REPORT OF: URBAN DESIGN COMMISSION	PRESENTED: June 16, 2010
TITLE: 517-523 East Main Street – PUD(GDP-SIP), Demolition for a 21-Unit Building. 6 th Ald. Dist. (18842)	REFERRED: REREFERRED: REPORTED BACK:
AUTHOR: Alan J. Martin, Secretary	ADOPTED: POF:
DATED: June 16, 2010	ID NUMBER:

Re: 517 – 523 East Main Street

First Settlement Historic District
Criteria for the review of new construction

Address: 517-523 E Main Street
Date: June 14, 2010 Landmarks Commission Meeting
Form Prepared By: R. Cnare and B. Fruhling

Section 33.19(5)(c) Regulation of Demolition

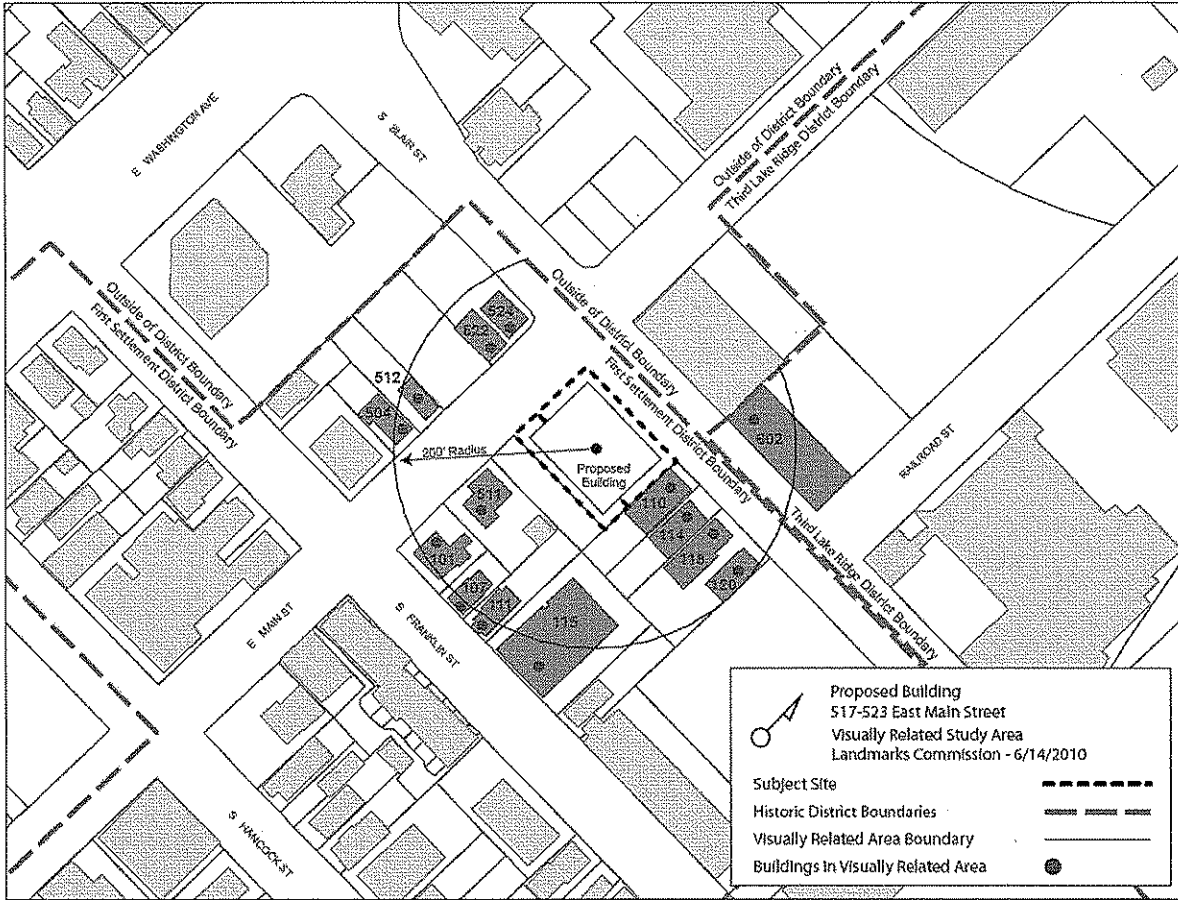
Staff believes that this building does not contribute to the distinctive architecture or historic character of the District, and therefore recommends that the Certificate of Appropriateness for the demolition of 517-523 East Main Street be approved.

Parcel to be redeveloped:

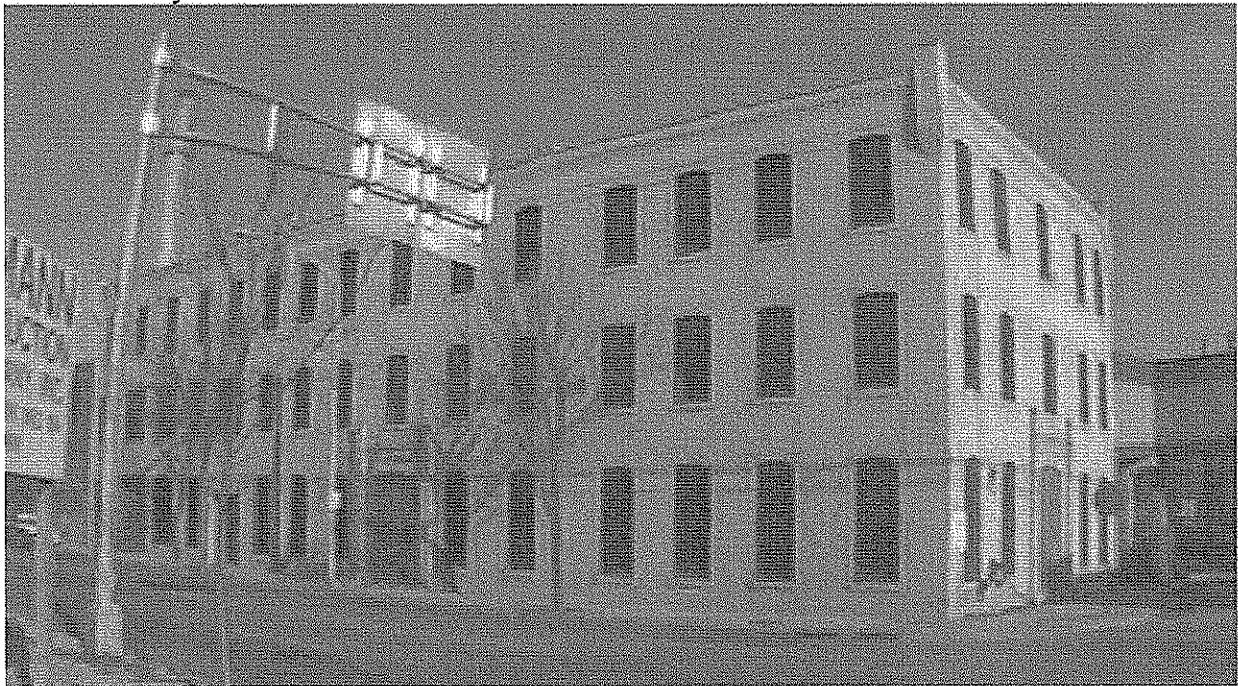
602 Railroad Street is directly across the street from the subject property and lies within the 200-foot boundary of inscribed circle of the Visually Related Area.
